Heckington Fen Solar Park

Cover Letter

Application by Ecotricity (Heck Fen Solar) Limited for development consent for the Heckington Fen Solar Park

**Response to the Planning Inspectorate's section 55 advice dated 13 March 2023
Ecotricity (Heck Fen) Solar Limited ("the Applicant")**

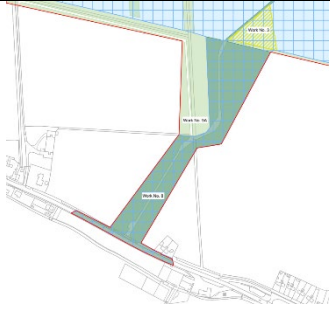
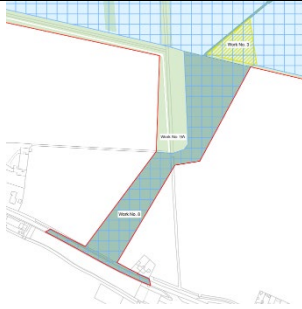
Box 30 - Point 2	Work Plans (Doc 2.2)	
	On sheet 5, Work No. 8 has a lighter green line running through it which is not identified in the legend.	The lighter line shown running through Work No. 8 on Sheet 5 was an indication of the new track location, which continues north. This has been removed and the Works Plans reissued as Document Reference 2.2 – V2. The Applicant has provided screenshots below for ease of reference:
	Previous Work Plan - Sheet 5	Revised Work Plan - Sheet 5
